Docket Item #3 & #4 BAR CASE # 2016-00342 & 00343

BAR Meeting November 2, 2016

Partial demolition and Addition/Alterations

317 South Lee Street

6. View of 2nd floor window to be encapsulated by new bridge over existing courtyard(looking East).

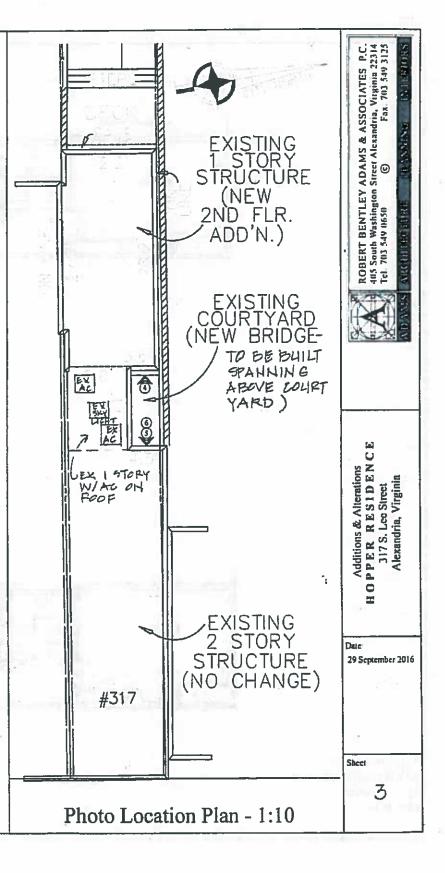
The applicant is requesting a Permit to Demolish for partial demolition of wall area at the rear of the main block and rear ell. The walls proposed to be demolished or capsulated include portions of the second floor inset above a small courtyard. The roof structure on the existing rear addition, constructed circa 2011, will be demolished to accommodate a second story addition.

The only historic fabric that will be lost is a portion of the rear wall of the main block and it is minimal in scope as well as of common design that could be easily reproduced. It is typical of what the BAR routinely approves for rear additions. Staff has no objection to the proposed demolition and capsulation which is minimal in scope and predominantly limited to the 2011 addition.
